We write further to earlier representations submitted to the non-statutory and statutory consultations concerning the proposed solar farm on land at Bracon Ash, Norfolk.

The solar farm is to be built on land proposed to be crossed by oversail between pylons RG18 and RG19.

Project:
Land at Bracon Ash
 Flordon Road, Norwich

Drawing Title:
SITE LAYOUT PLAN

1 LAND AT BRACON ASH: SITE LAYOUT PLAN
 Scale: 1:2500@A1

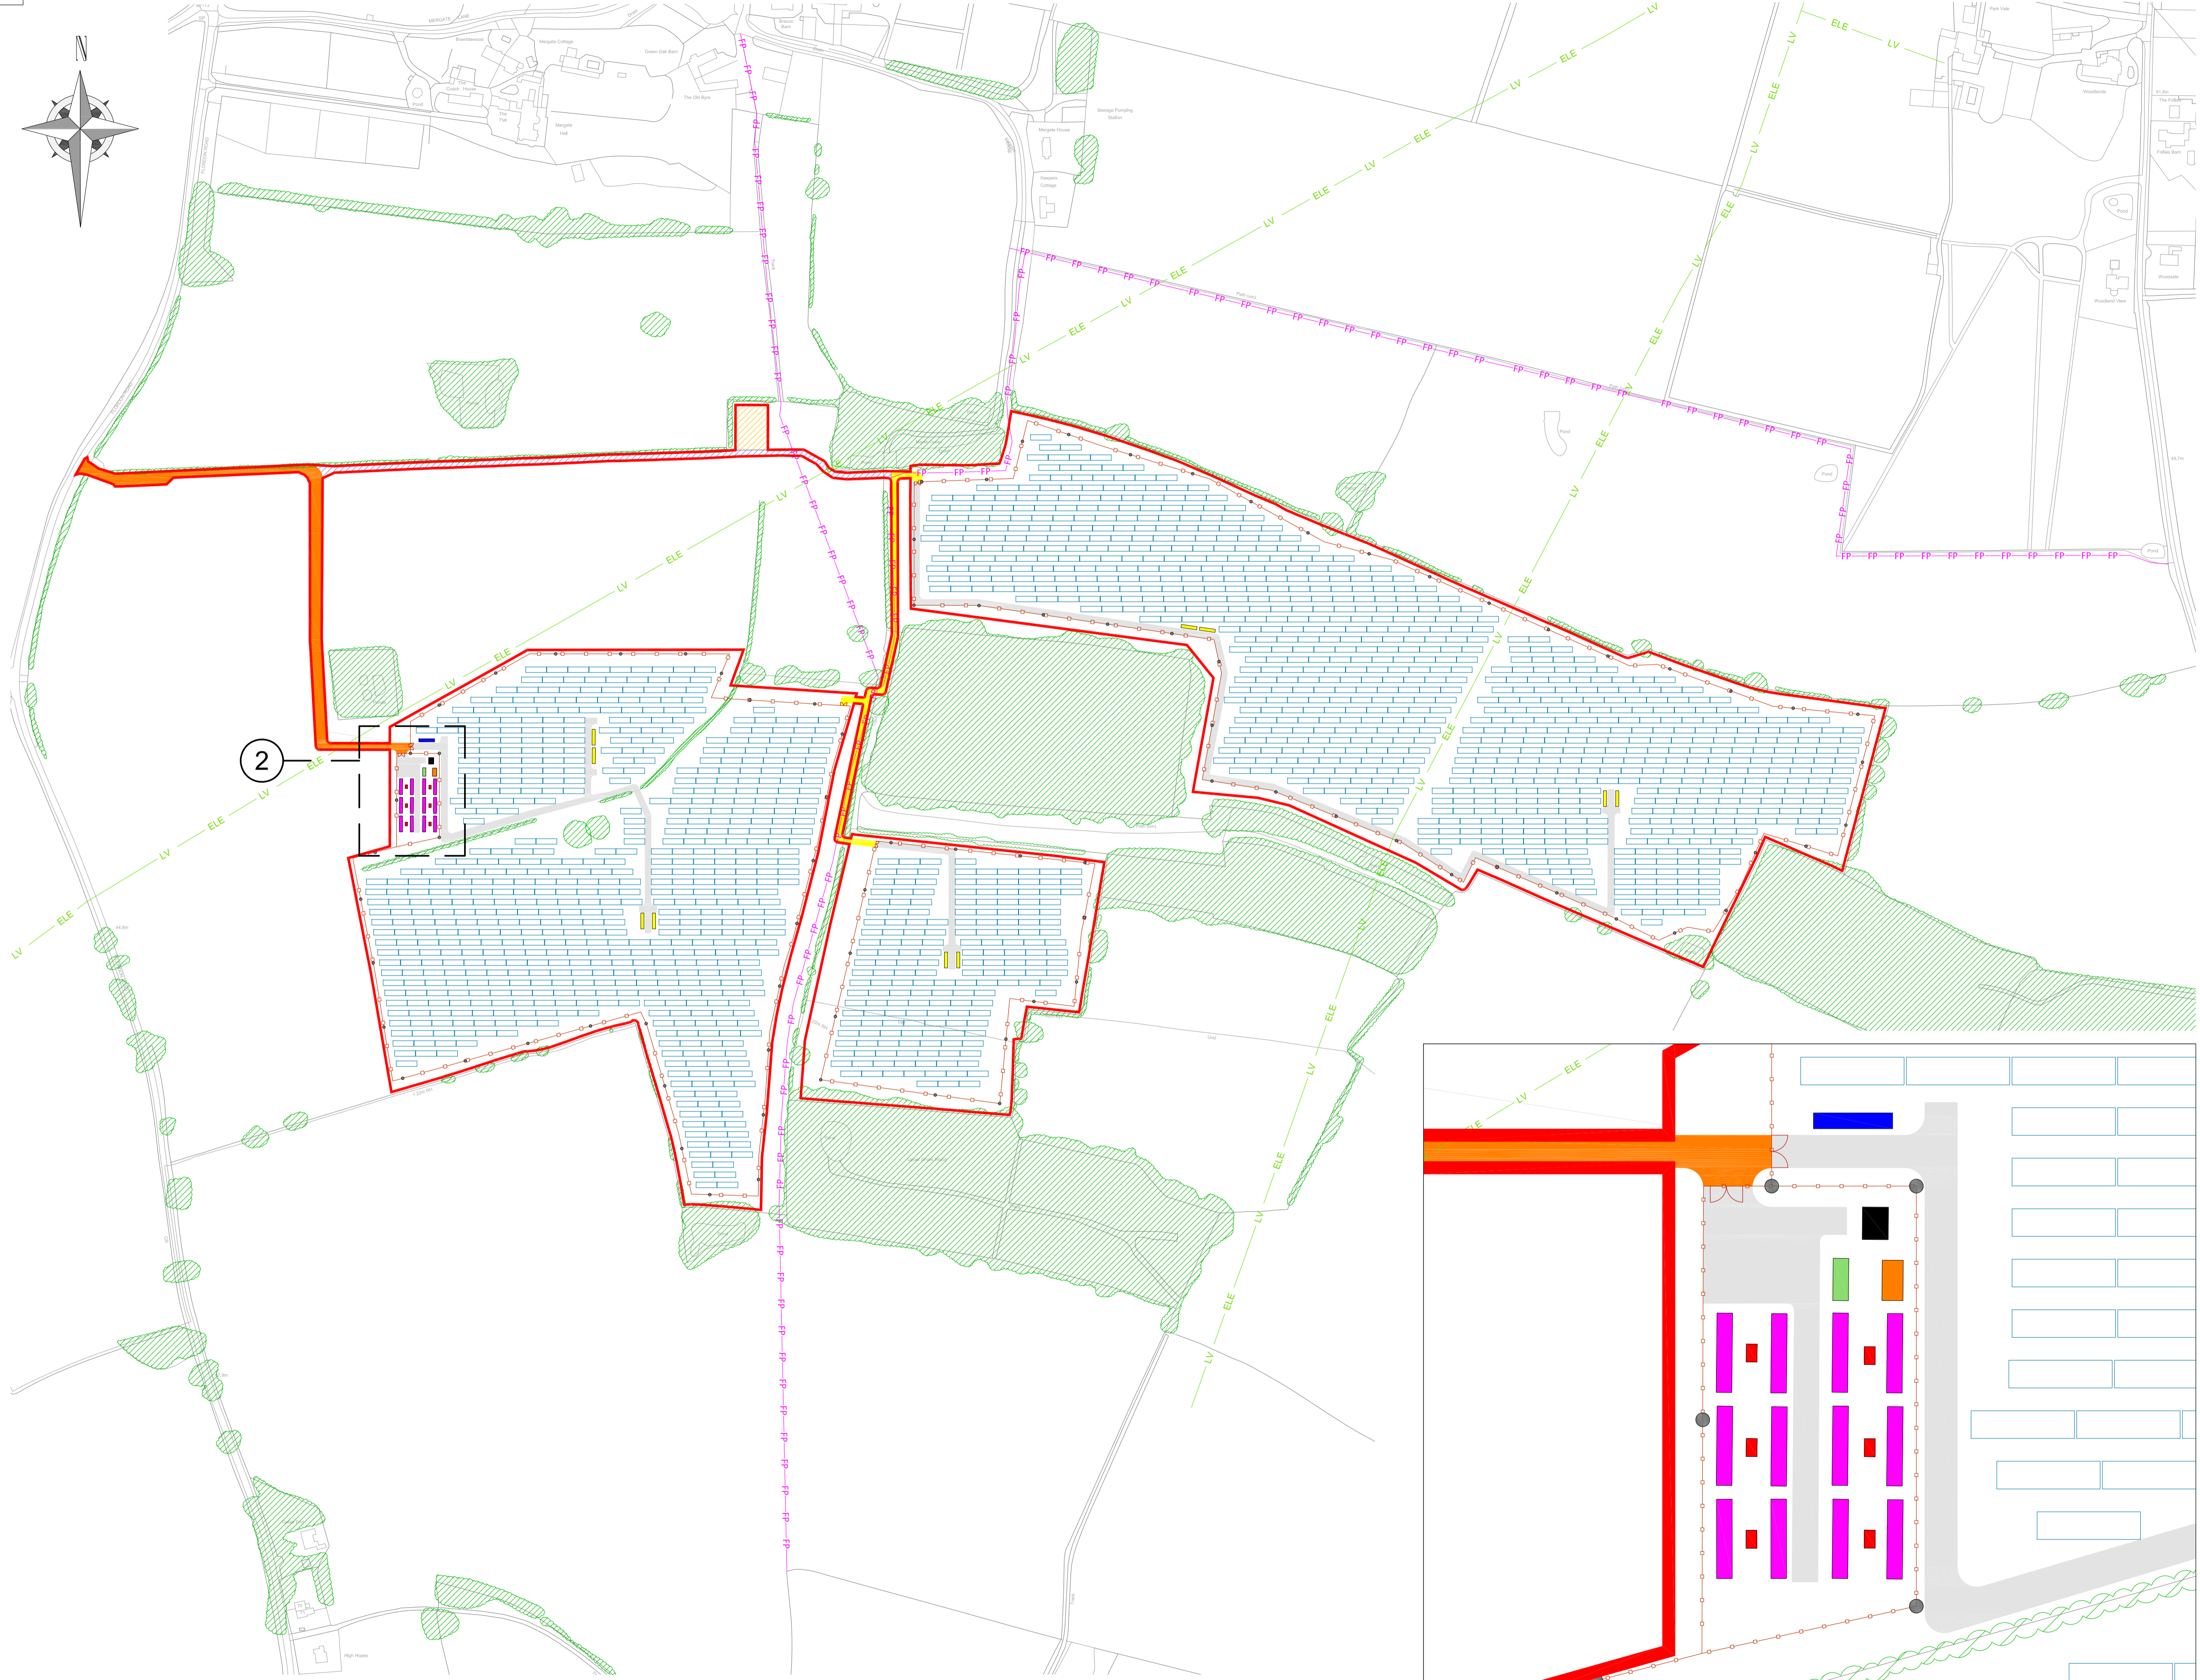
The proposed oversail will cross part of the solar farm area so, again, it is requested that the span between RG18 and RG19 is realigned to the east to reduce the impact of the oversail on the solar project, preferably avoiding the solar farm site altogether but any movement of the line eastwards would reduce the impact on the solar farm.

We do not believe the two projects are compatible and, therefore, the prospect of oversail on the solar farm should be removed by the realignment of the line as we have previously and are currently requesting.

We, therefore, request again that the route of the overhead line be moved to the east to avoid the proposed solar farm as shown on the layout plan attached as any works undertaken on the site that are associated with the Norwich to Tilbury project will impact the proposed solar farm’s operational capability.

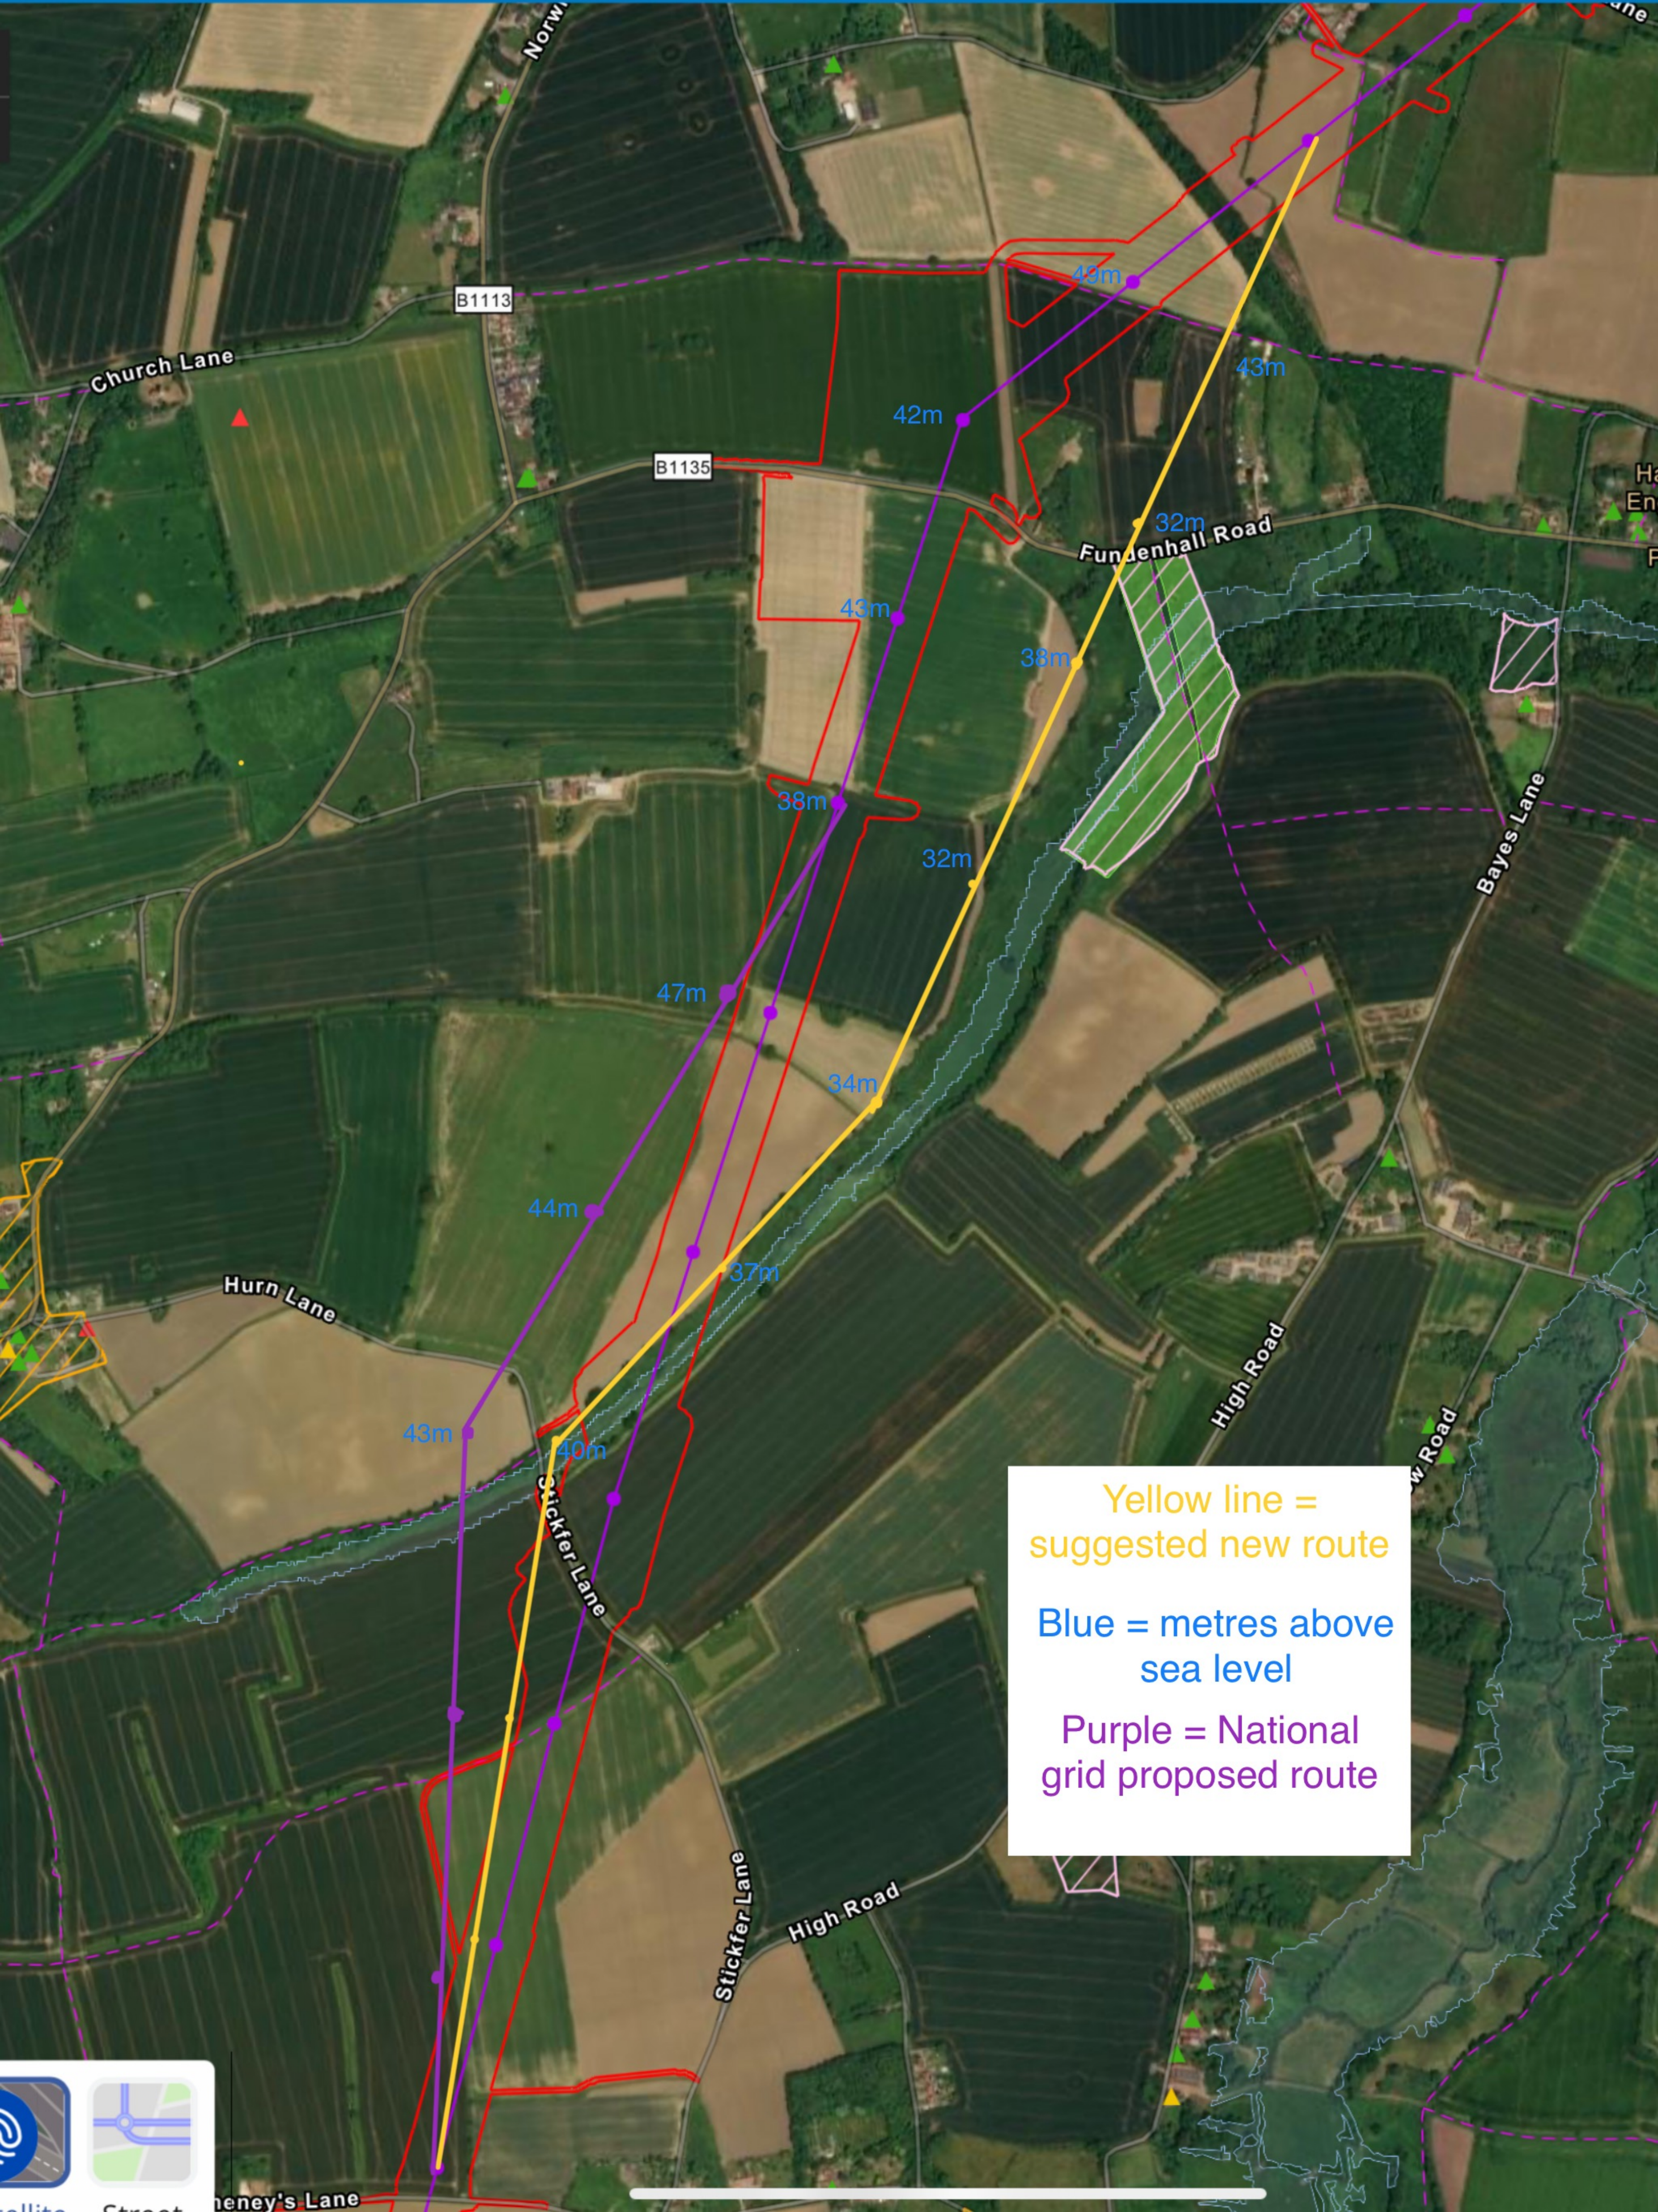
Previous representations submitted have requested that National Grid move this section of the alignment east to reduce the impact on the land proposed for the solar farm as shown in red on the plan attached, which accompanied the Design Change Request of 21-08-2023. These requests were ignored by National Grid, and no change of alignment has been made.

Yellow line = suggested new route

Purple = National grid proposed route
